**PLANNED UNIT DEVELOPMENT
& SUBDIVISION STAFF REPORT****Date: March 18, 2010****DEVELOPMENT NAME**

Congress Street Subdivision, Resubdivision of

254 Congress Street
(North side of Congress Street, 60'+ West of North Joachim Street, extending to the West side of North Joachim Street, 78'+ North of Congress Street).

Planned Unit Development Approval to amend a previously approved Planned Unit Development to allow shared access and parking between multiple building sites, and Subdivision approval to create 4 lots.

SUBDIVISION DETAIL

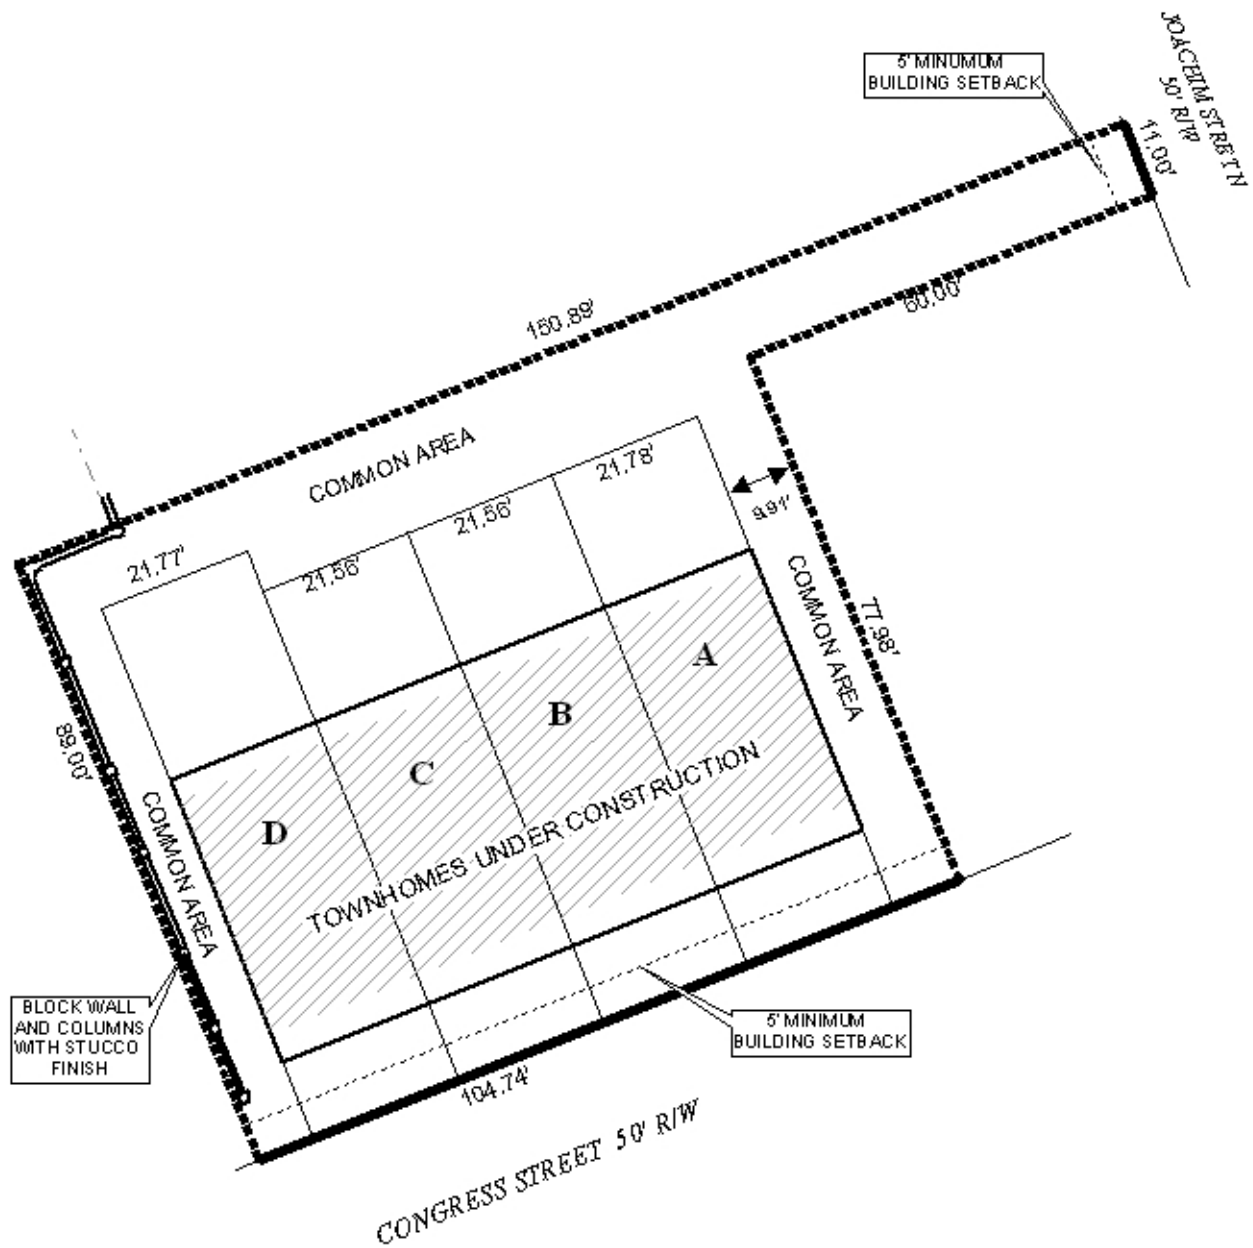
The site is zoned R-B, Residential-Business District, thus the multi-family residential uses are allowed by right. Furthermore, this district allows up to 75% site coverage and a 5-foot front yard setback and zero-foot side and rear yard setbacks. It should be noted that the 5-foot minimum building setback line is depicted on the plat and site plan.

It should be noted that the lot sizes will not comply with Section 64-3.D.1.b. of the Zoning Ordinance regarding the minimum building site area being less than 5,000 square feet in a R-B, Residential Business District.

It should be noted that the applicant has illustrated common areas on the plat; therefore, a note should be placed on the Final Plat stating that maintenance of these areas will be the responsibility of the property owners.

- 1) the subdivision does not comply with Section 64-3.D.1.b. of the Zoning Ordinance regarding minimum building site area; and
- 2) potential building code issues concerning the fire separation wall.

SITE PLAN

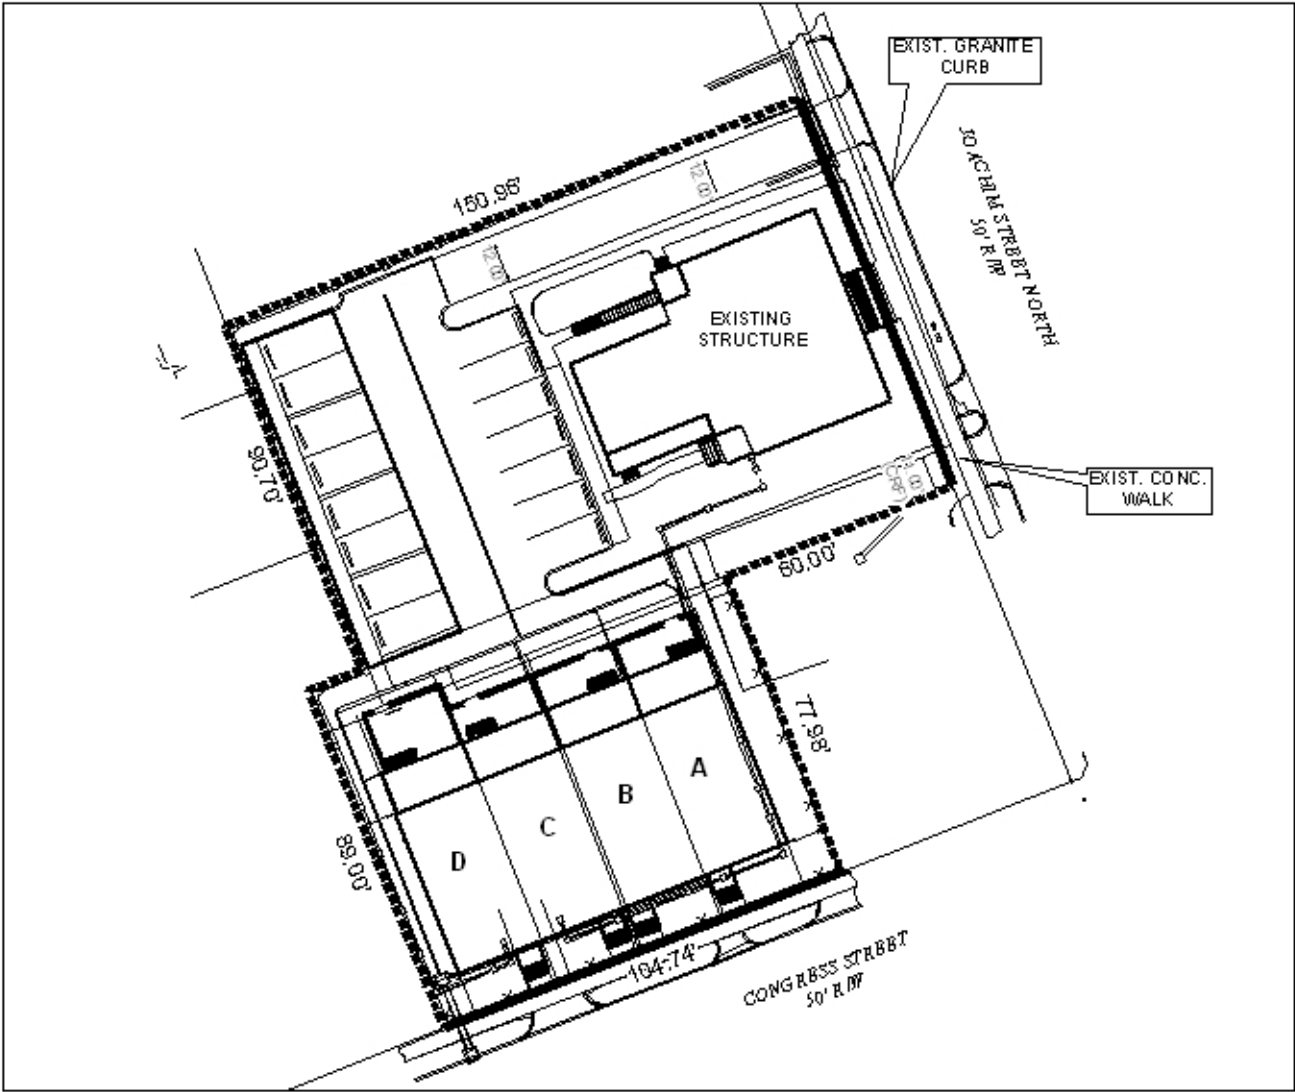
The proposed parking area will be accessed via a one-way entrance from North Joachim Street, and will exit via a separate one-way entrance onto North Joachim Street. It appears that the entry drive will be approximately 12-feet wide; however, it appears that the exit drive will fall below this dimension.

Dumpster locations for the site are not depicted on the site plan to comply with Section 64-4.D.9 of the Zoning Ordinance; therefore, the applicant should make a provision for dumpster locations and place a note on the site plan stating that dumpsters will be completely screened from view. If dumpsters will not be used, provide a statement indicating such, and how garbage will be removed from the site.
